RE: Sanitary Sewer Overflow/Collection System Inspection

AFIN: 04-00052 NPDES Permit No.: AR0022292

ADEQ Water NPDES Inspection AFIN: 04-00052 Permit #: AR0022292

Photo #
 2
 Of
 3
 Date:
 03/23/10
 Time:
 1615

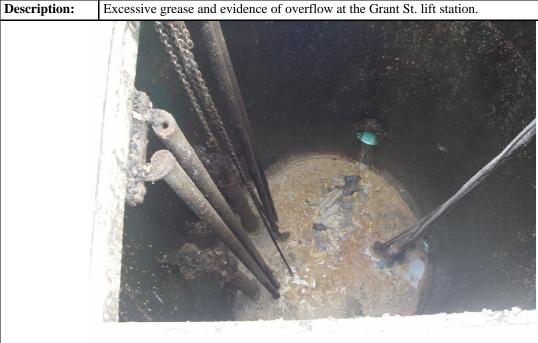
Water Division NPDES Photographic Evidence Sheet												
Location:	City	of De	ecatur Co	llection System									
Photograph	er:	Dale W	Vasham		Witness:	John Fazio							
Photo #	1	Of	3		Date:	03/23/10	Time:	1606					
Description	<b>Description:</b> Excessive grease and evidence of overflow at the Park lift station.
